Our Ref T22- 000
Your Ref: 20032138 Rep 119/Rep 120
3 April 2023

A66 Trans-Pennine Project Scheme 0102 – M6 Junction 40 to Kemplay Bank

Mis-labelled Drawings

Title: **A66 - National Highways Land**
Scale: 1:1250 @A4
Date: 03 Mar 2023
Drawn By: _____
Drawing No: _____

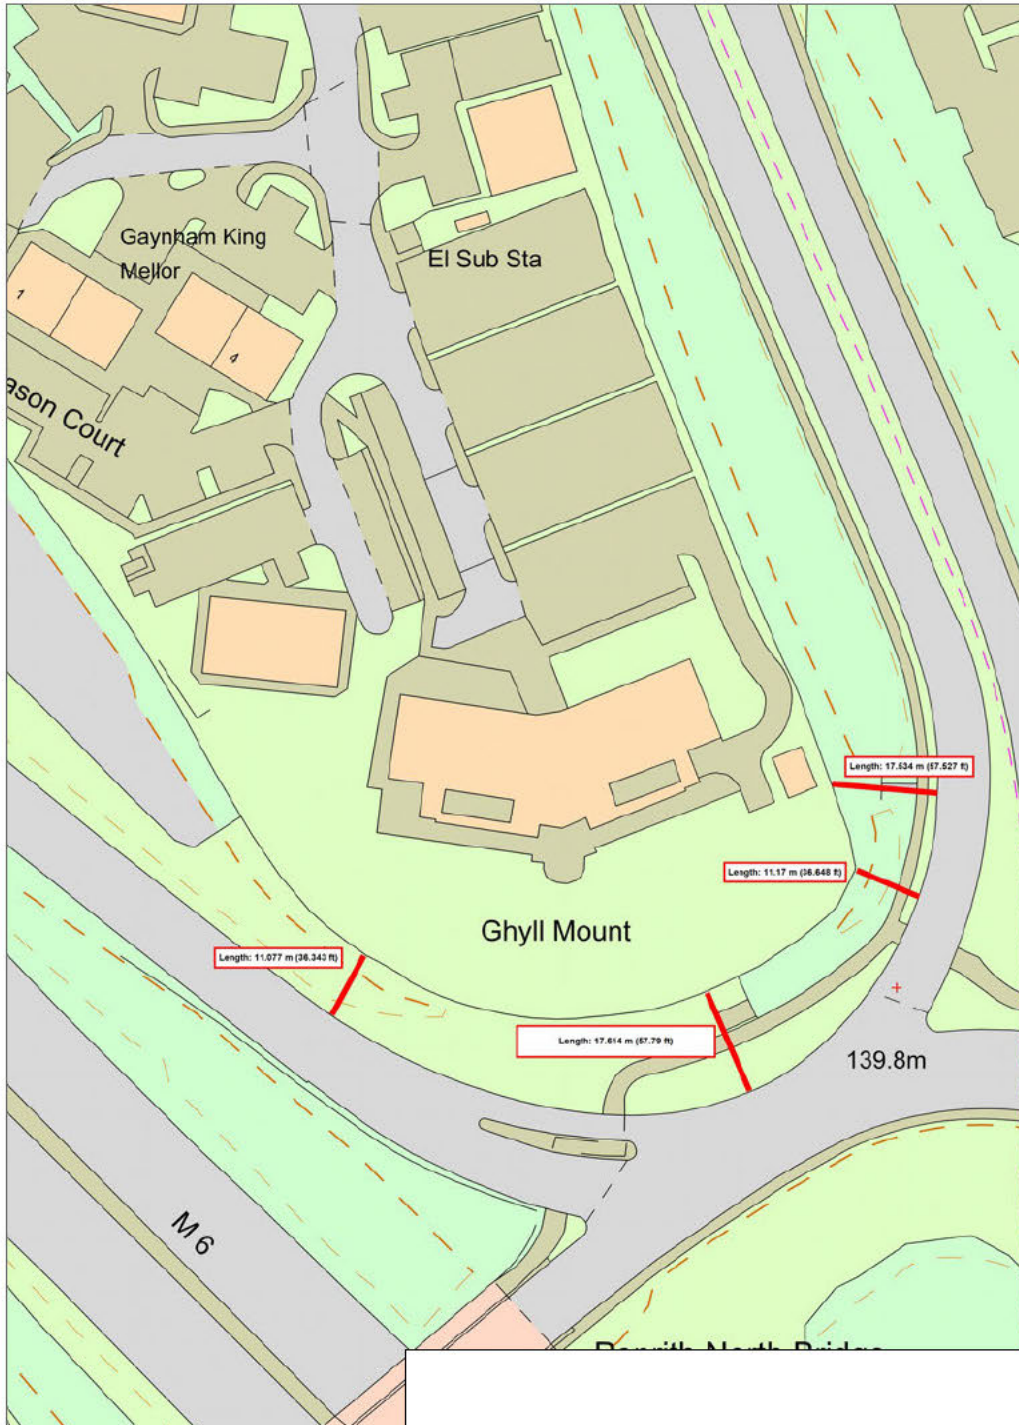
The scale plan attached at attachment 2 shows the depth of existing National Highways land adjoining 0102-01-20.

As demonstrated in document 7.30 Appendix G the available land within National Highways existing ownership adjoining 0101-01-20 is sufficient to accommodate the non-motorised user facilities without requiring additional land.
